BCAC ADM Item 33

Delete entire appendix:

The following is an existing figure in IBC Commentary.

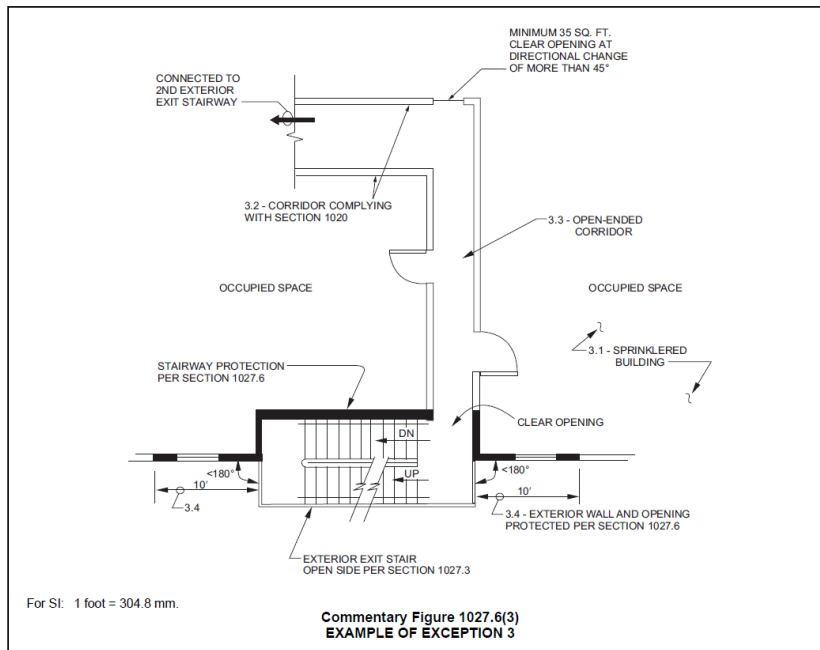
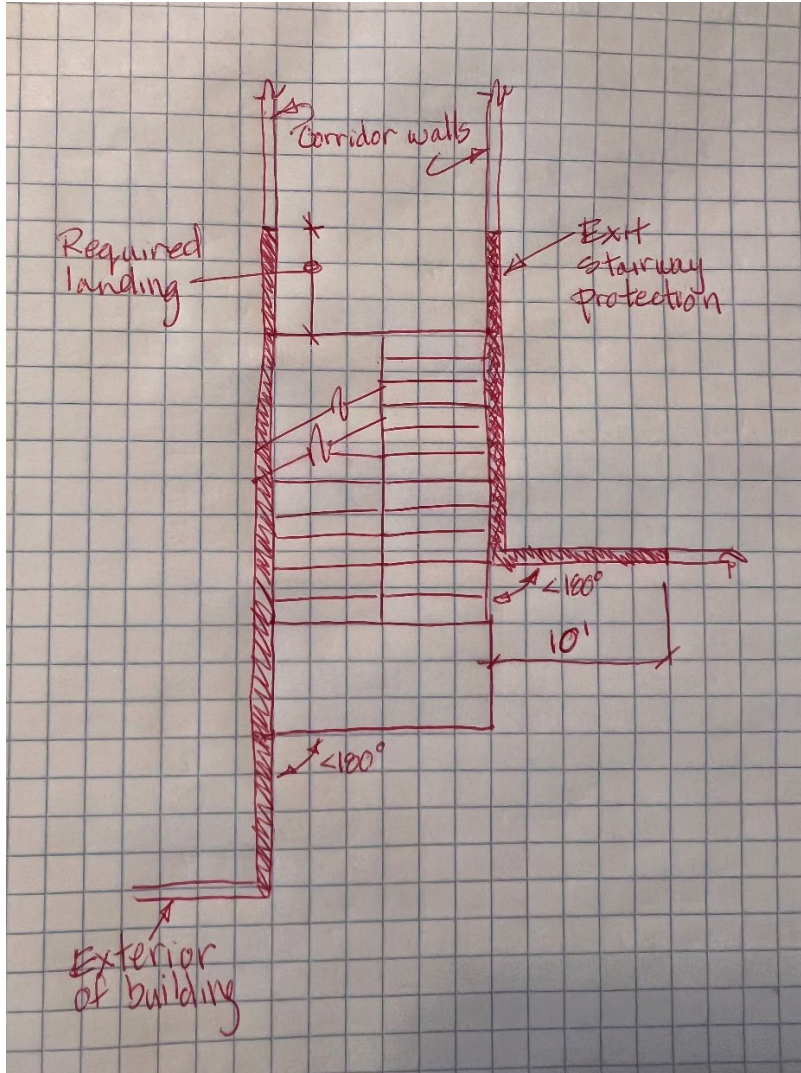
Question is where the wall requirements for the stairways stop? I don't think they need the 10 shown in this picture. Question is on Section 1027.6 Exception 3 if you remove the end wall of the stairway that is towards the breezeway.

Another question was about what you did at the bottom if the stairway was shoved into the building.

1. Address the rating/separation requirements for exterior exit stairways that are open to a breezeway

2. To address where a stairway may be recessed into the footprint of the building.

There has been a misinterpretation that the walls on the open-ended corridor are exterior walls in accordance with Item 3.4 instead of the corridor in accordance with 3.2. This can lead to unnecessary ratings on the corridor walls. The added sentence in 3.3 clarifies this.

The sentence added in the base paragraph is to address a situation where the exterior exit stairway is completely recessed into the building. It is not clear if the walls between the exterior exit stairway and the exterior of the building is an exterior wall. However, BCAC felt the stairway does need to be available for people to leave the building, so the protection needs to be available.

The illustration below gives an orientation of a rotated stair that is partially within the building, illustrating where the rating would stop at the extent of the landing as well as illustrating how the requirement for the ten foot of exterior wall is required to be rated when less than 180 degrees.

1027.6 Exterior exit stairway and ramp ~~protection~~ separation. *Exterior exit stairways and ramps* shall be separated from the interior of the building as required in Section 1023.2. Openings shall be limited to those necessary for egress from normally occupied spaces. Where a vertical plane projecting from the edge of an *exterior exit stairway* or *ramp* and landings is exposed by other parts of the building at an angle of less than 180 degrees (3.14 rad), the *exterior wall* shall be rated in accordance with Section 1023.7. Where the exterior exit stairway is recessed into the building, the separation for the exterior exit stairway or ramp shall extend to the exterior walls.

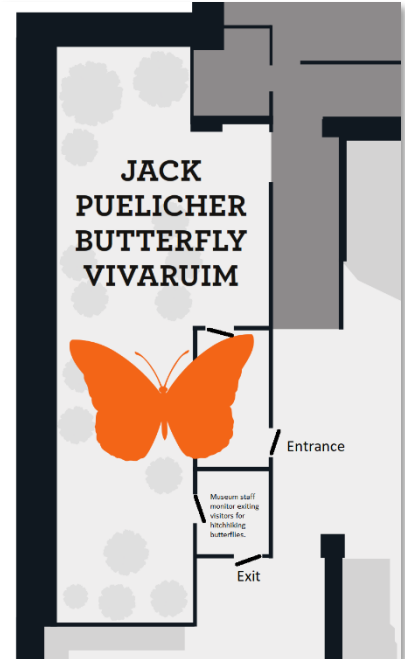
The IBC is currently silent regarding requirements and guidance for control vestibules. This proposal does not require installation of control vestibules, but offers requirements (guidance) for where control vestibules are incorporated in the means of egress.

This proposal addresses egress related requirements for control vestibules. Control vestibules which provide security or access control on the ingress side of doors into a building or into a space within a building are more common than control vestibules on the egress side of doors in the means of egress from a space or from a building. Requirements for the access-side of control vestibules is typically outside the scope of the IBC. Thus access-side control vestibules are not regulated or prohibited by the IBC provided all requirements for egress are complied with. This proposal addresses control vestibules in the means of egress with egress-side requirements.

Control vestibules must provide for egress. Together, the definition and proposed requirements provide for egress where control vestibules are installed.

1010.2.15.3 Interlocking door operation. Where doors in the means of egress are configured as a control vestibule, the control vestibule door interlocking system shall provide for egress. The control vestibule shall comply with all of the following:

Milwaukee Public Museum Butterfly Vivarium

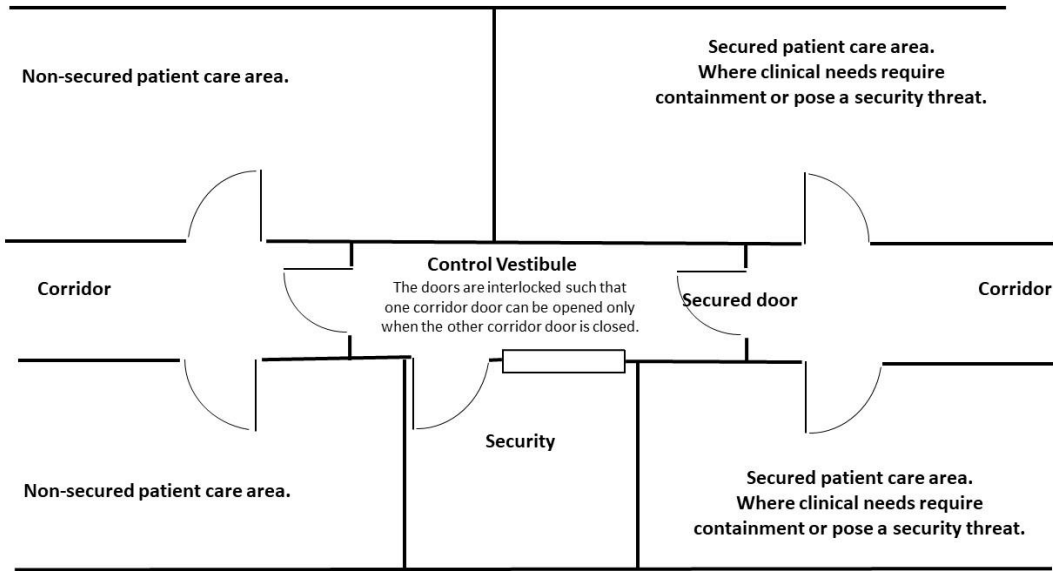
This picture and floor layout of the butterfly vivarium at the Milwaukee (Wisc.) Public Museum illustrate a potential application of a control vestibule. The vestibule and doors for one-way passage into the butterfly vivarium are currently configured as an “on your honor” control vestibule. The sign on the inner door advises visitors to the vivarium to wait for the outer door to close before opening the second door to enter. With electrical locks on the two doors, and with related controls, this space could be configured as a control vestibule. This proposal addresses requirements of control vestibules from an egress perspective, but not from an ingress perspective. In this butterfly vivarium example, the code’s requirements affect how the control vestibule would be configured to ensure egress.

The one-way out vestibule on the exit side of this vivarium (see the floor plan) is also an “on your honor” control vestibule. A museum staff person is stationed inside the exit vestibule tasked with ensuring butterflies do not escape with visitors, and with ensuring in each of these two vestibules that both doors in the vestibule are not open at the same time. Installing electrical interlocks and controls on the doors of these vestibules to create control vestibules would relieve the staff person from carefully watching the doors and enable the staff person to interact more with the visitors.

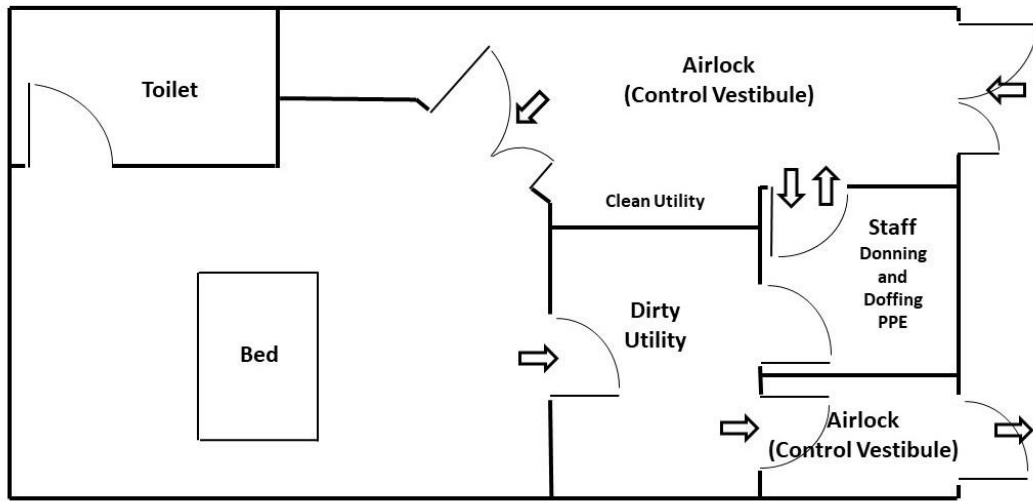
A control vestibule may be used in healthcare applications to prevent patients in the secured patient care area from making a successful "run for it" when the secured door is opened.

This is an example of an application of a control vestibule in the corridor between secured and non-secured patient care areas in a healthcare setting. The secured patient care area is for patients with clinical needs that require containment or pose a security threat.
